BABCOCK PRUE ROAD
PRELIMINARY OVERALL DEVELOPMENT
PLAN

INFORMATION SHEET FOR
PRELIMINARY OVERALL AREA DEVELOPMENT PLAN
(P.O.A.D.P.)

Re: Babcock Prue Road POADP
File # 85-12-62-02

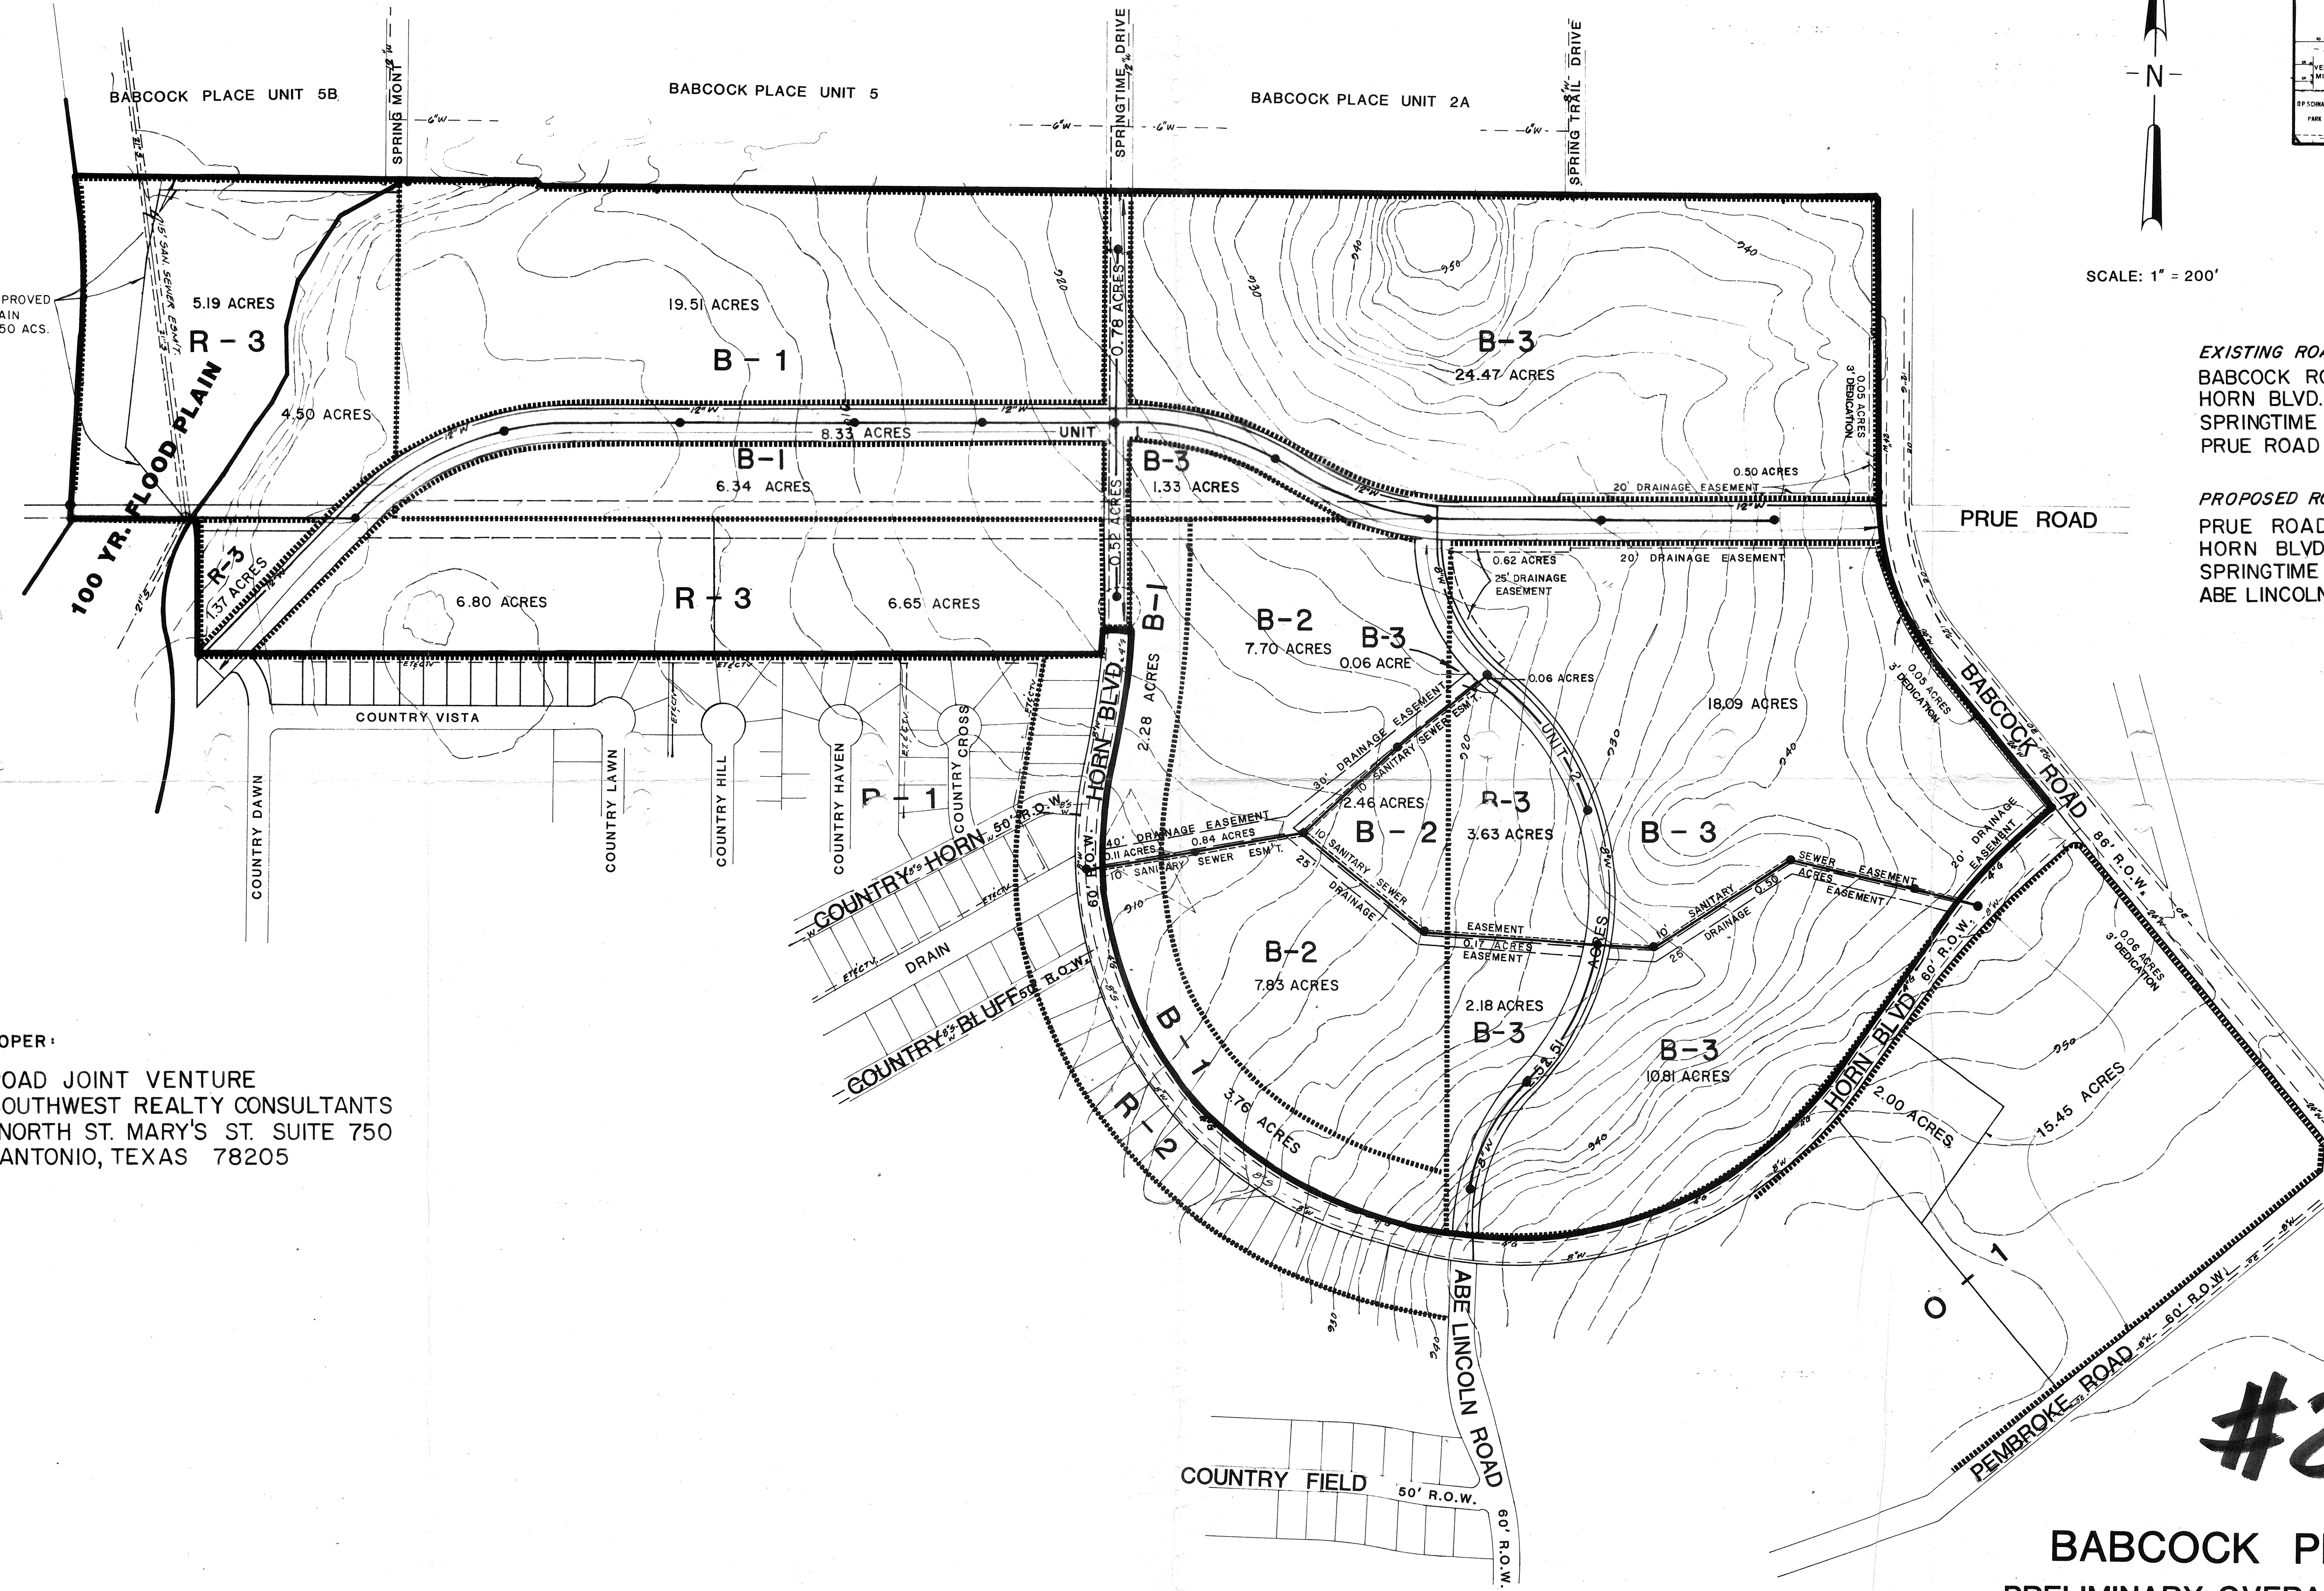
The POADP Committee has reviewed and accepted the attached plan for Babcock Prue Road. Springmont Drive and Spring Trail Drive will be cited as deadend streets during the platting process. Staff would suggest that you work closely with the Traffic Section of the Department of Public Works to resolve this situation.
